Russell Brady, Contract Planner
County of Riverside
June 10, 2024
Page 20

Letter B Responses to Comments from the California Department of Fish and Wildlife (CDFW)

Letter F Responses to Comments from the Center for Biological Diversity

Figure 3-5

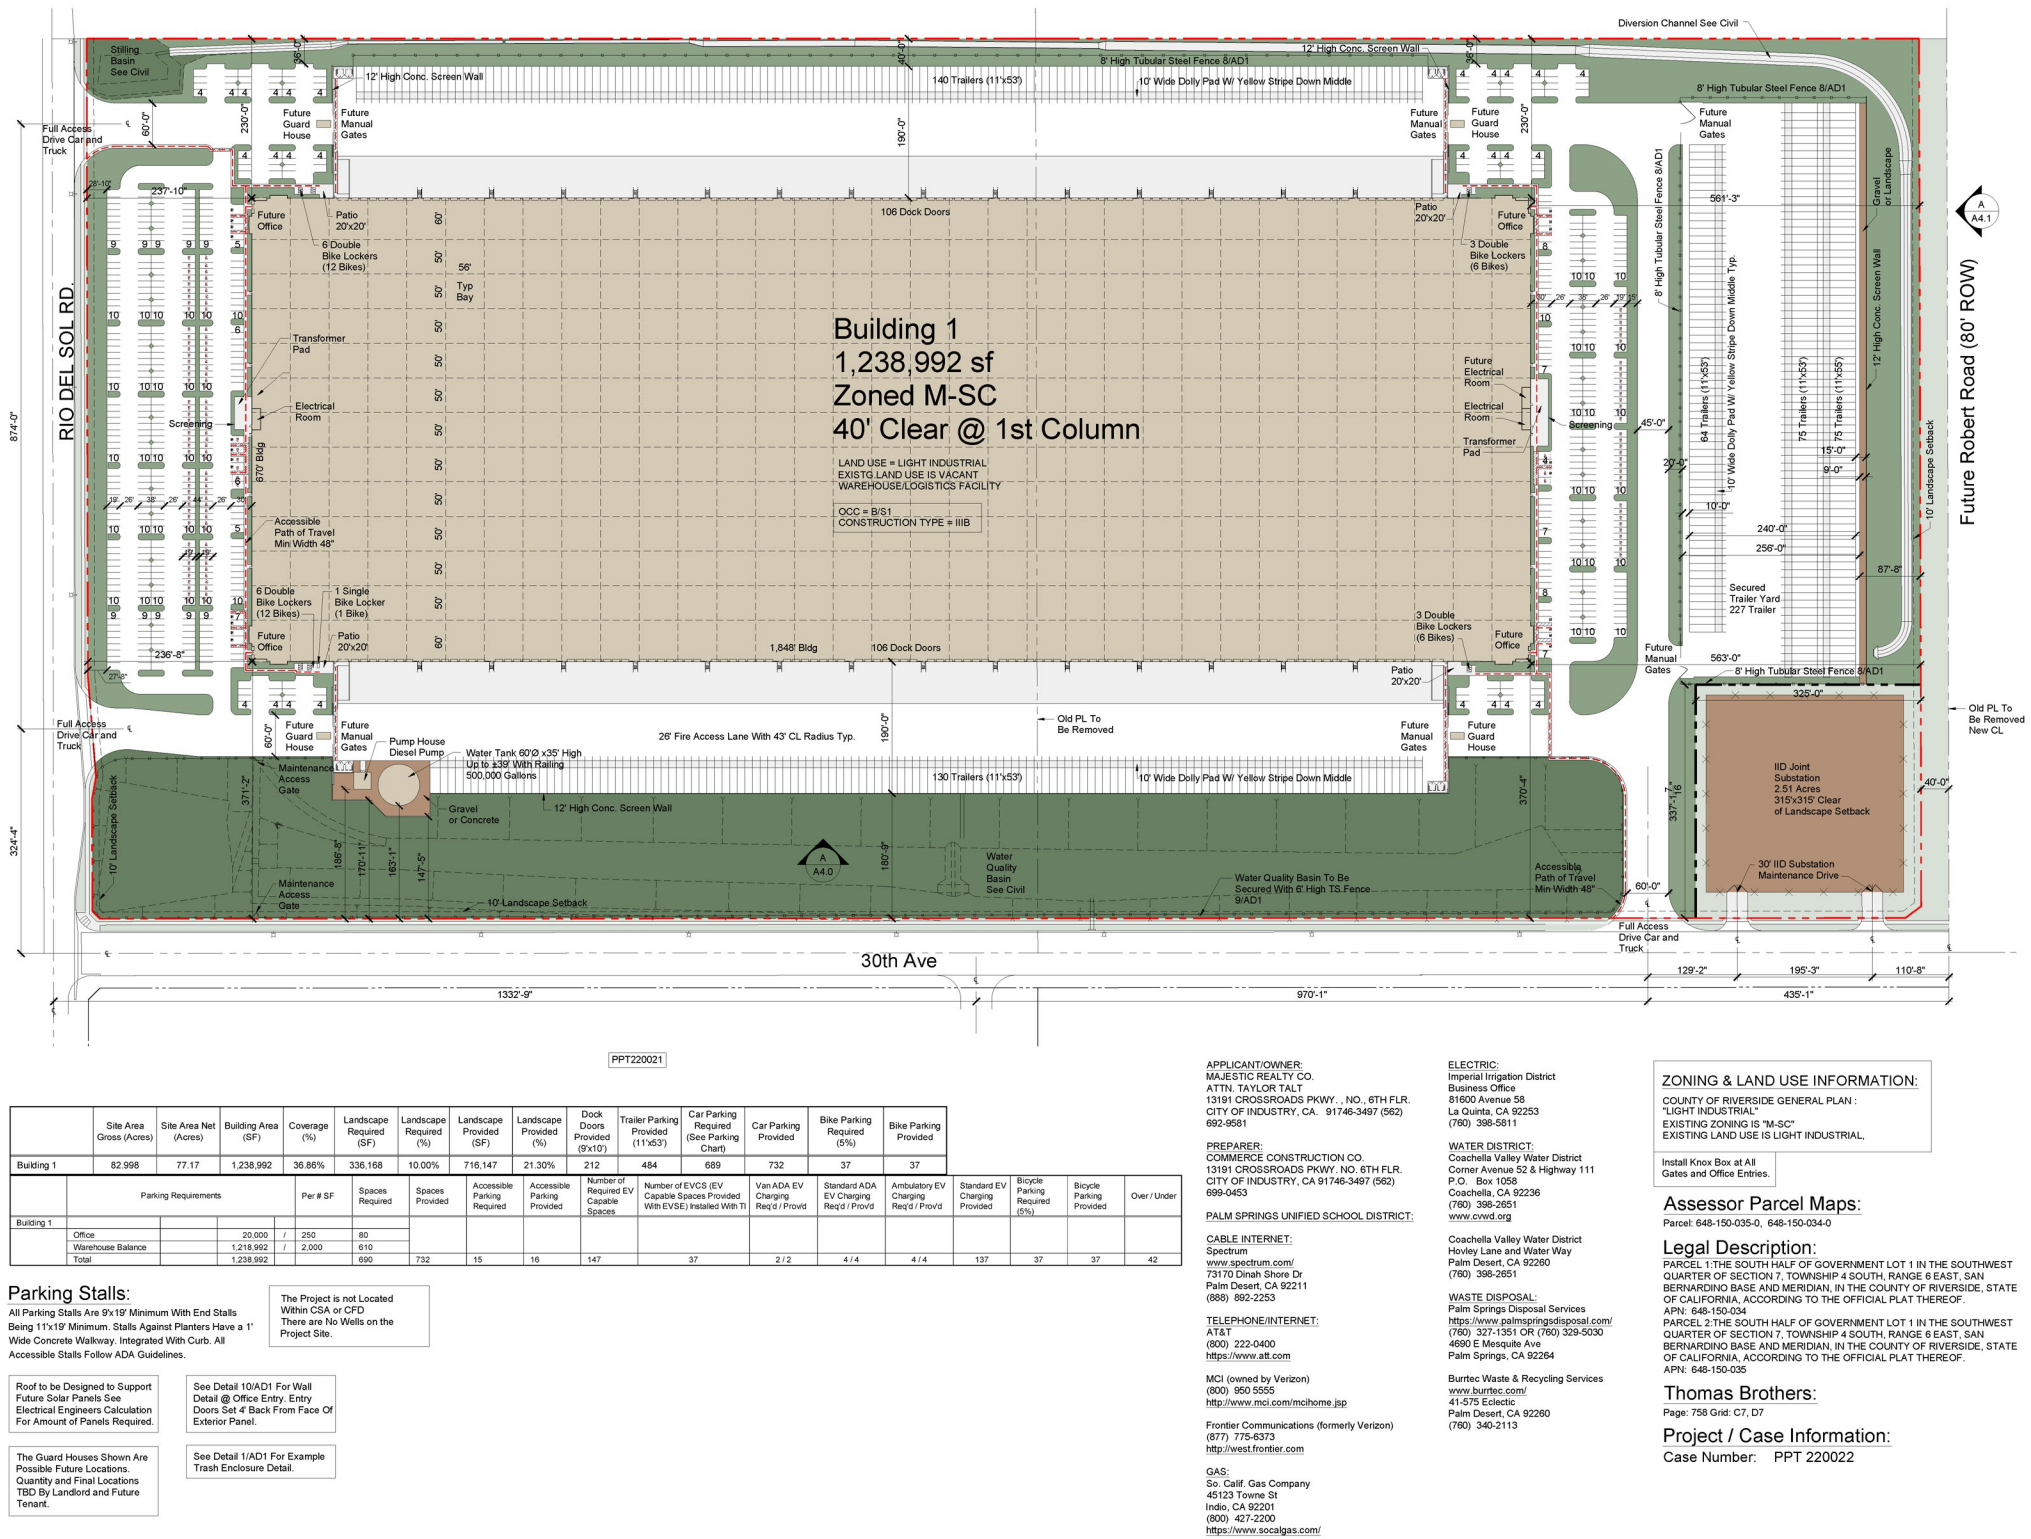
C-11 The commenter recommends that a design consideration be added stating, “Design the Proposed Project such that truck entrances and exits are not facing sensitive receptors and trucks will not travel past sensitive land uses to enter or leave the Proposed Project site.” The commenter is referred to the Project’s proposed site plan, which is depicted on DEIR Figure 3-5. As shown, all Project-related

The second measure recommended by the commenter is to screen the dock doors and on-site areas with significant truck traffic with physical, structural, and/or vegetative barriers. As shown on DEIR Figure 3-5, both of the Project's truck courts would be surrounded by 12-foot-tall concrete screen walls, which would obstruct public views of the truck courts. In addition, and as shown on DEIR Figure 3-16, *Plot Plan No. 220022 Conceptual Landscape Plan*, the Project incorporates the maximum amount of landscaping as is feasible given site design constraints and the Project site's location within a desert environment, and the landscaping proposed largely would obstruct views of the drive aisles where trucks would travel to access the truck courts. Accordingly, no revision to the DEIR is necessary pursuant to this recommended mitigation measure.

truck traffic would be routed either directly to Rio del Sol or would be routed to 30th Avenue to access Rio del Sol. None of the entrances proposed as part of the Project face sensitive receptors. Furthermore, it is noted that the nearest sensitive receptor is located 1,329 feet to the east of the Project site (as depicted on DEIR Figure 4.3-1), and none of the Project's truck entrances are oriented to the east. Furthermore, the analysis throughout the DEIR demonstrates that the Project's localized impacts, including potential localized air quality, health risk, and noise impacts, all would be less than significant. Pursuant to Section 15126.4(a)(3) of the State CEQA Guidelines, "[m]itigation measures are not required for effects which are not found to be significant." Accordingly, no revision to the DEIR is warranted pursuant to this comment.

Figure 3-18

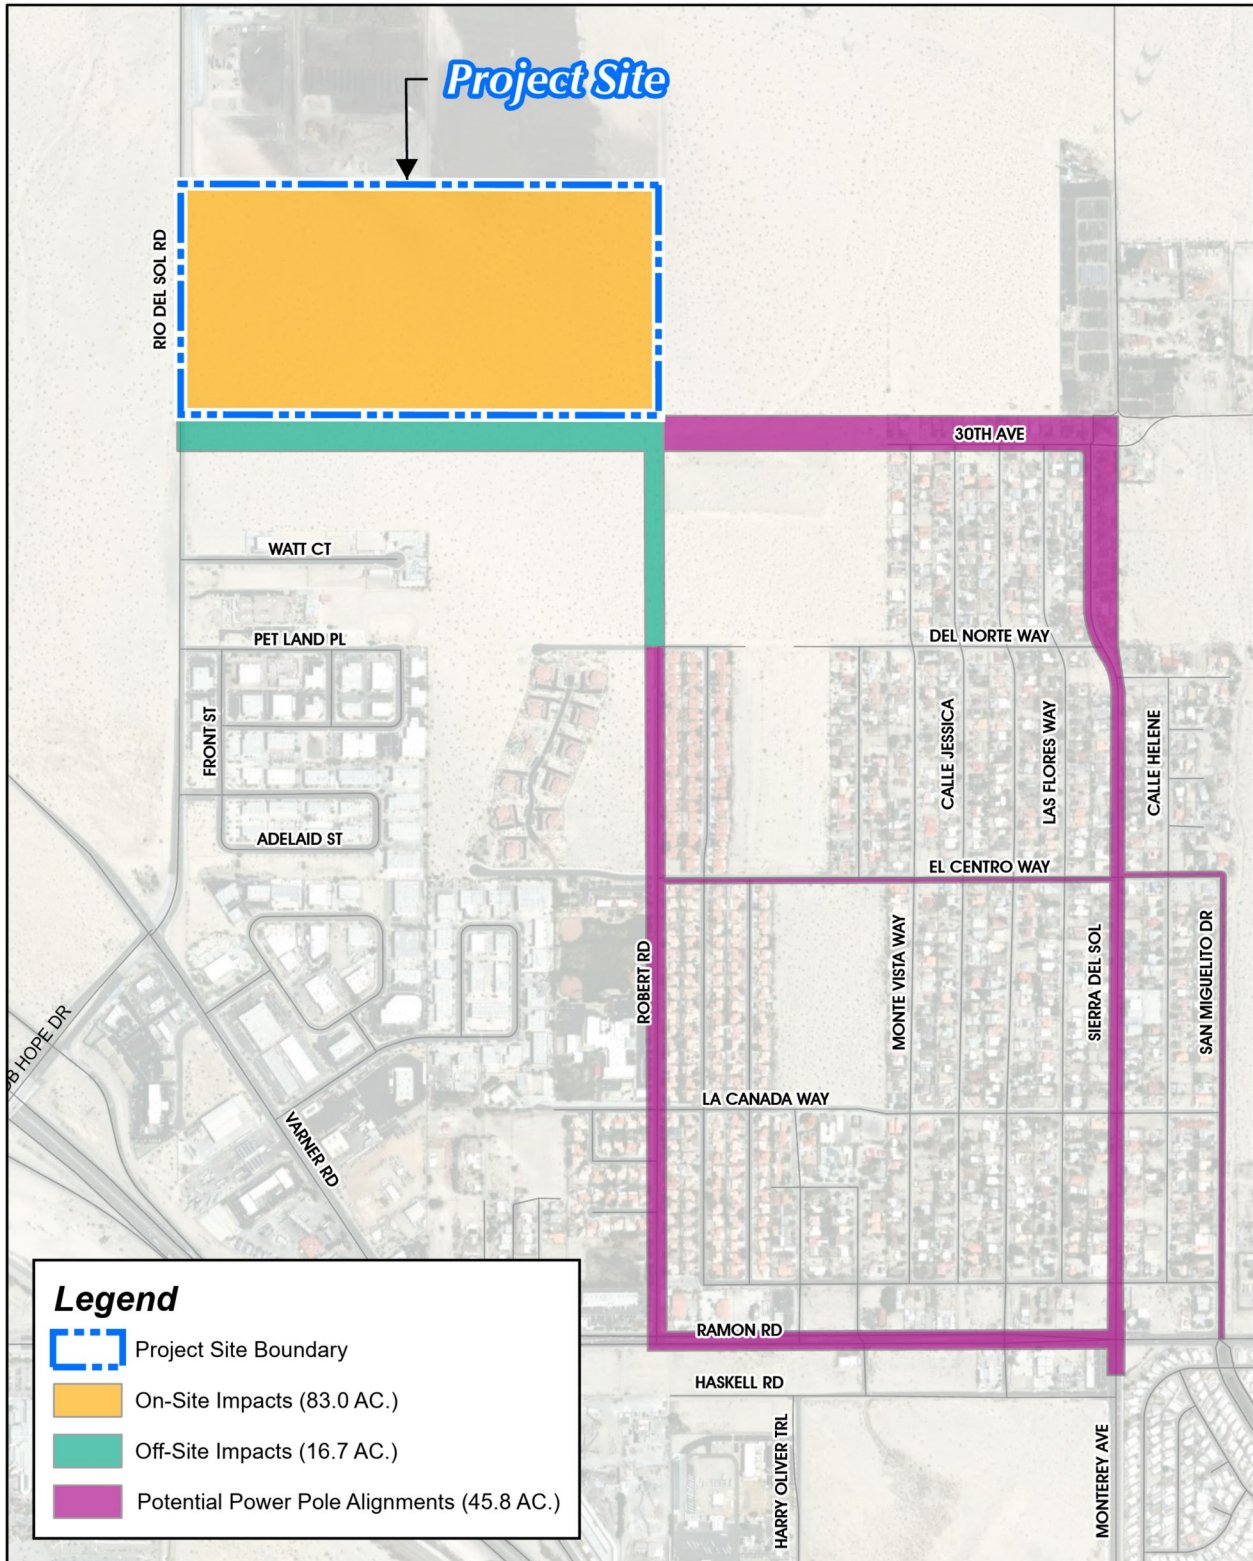
E-8 The commenter inaccurately states that the DEIR says that 70-foot power poles associated with the substation will be "constructed throughout the neighboring community" and incorrectly asserts that the DEIR evaluated only off-site roadway impacts. The commenter is referred to DEIR Figure 3-18, *Limits of Disturbance*, and the description of the Project's physical disturbances as presented in DEIR Subsection 3.6.1(B). As indicated therein:

*"Although the limits of disturbance depicted on Figure 3-18 shows full disturbance to approximately 45.8 acres along these road segments, the only areas that actually would be physically disturbed as part of the Project evaluated herein include areas where individual power poles and appurtenant facilities would be installed, resulting in impacts to a roughly maximum 10-foot by 10-foot area that would extend to a maximum depth of 15 feet at each pole location. Additionally, in the event the IID substation is constructed on site, **only one route would be selected for the proposed power poles and power lines between the proposed on-site IID substation and existing IID facilities, meaning that the majority of the off-site power pole alignments shown on Figure 3-18 would not be disturbed as part of the Project.**" (DEIR at p. 3-30; emphasis added)*

Thus, the commenter's allegation that the power poles would be "constructed throughout the neighboring community" is not accurate, as only one of the power pole alignments depicted on Figure 3-18 ultimately would be implemented. Furthermore, potential environmental effects associated with the off-site installation of the power poles are evaluated throughout the DEIR. For example, the analysis of Thresholds a. through c. in DEIR Subsection 4.1, *Aesthetics*, includes a full analysis of potential visual quality impacts associated with the off-site power poles, and this comment does not identify any deficiencies with the analysis or conclusions presented in DEIR Subsection 4.1. The commenter also is referred to the discussion and analysis of Project impacts to biological resources, cultural resources, and tribal cultural resources in DEIR Subsections 4.4, 4.5, and 4.19, respectively, all of which account for potential impacts associated with the off-site power poles. It is unclear what the commenter is referring to when referencing "safety issues" associated with the power poles. With respect to temporary construction-related impacts, the commenter is referred to the discussion and analysis of Thresholds e. and f. in DEIR Subsection 4.18, *Transportation*, which concludes there would be a potentially significant safety impact related to temporary disruptions to traffic during power pole installation, and imposes Mitigation Measure MM 4.18-1, which requires the Project Applicant to prepare and obtain Riverside County approval of a temporary traffic control plan prior to issuance of grading permits. Under long-term operating conditions, there would be no safety issues associated with the power poles, and this comment does not identify any specific safety issues under long-term conditions. As this comment does not identify any specific deficiencies with the analysis presented in the DEIR, no revision to the DEIR is warranted pursuant to this comment.
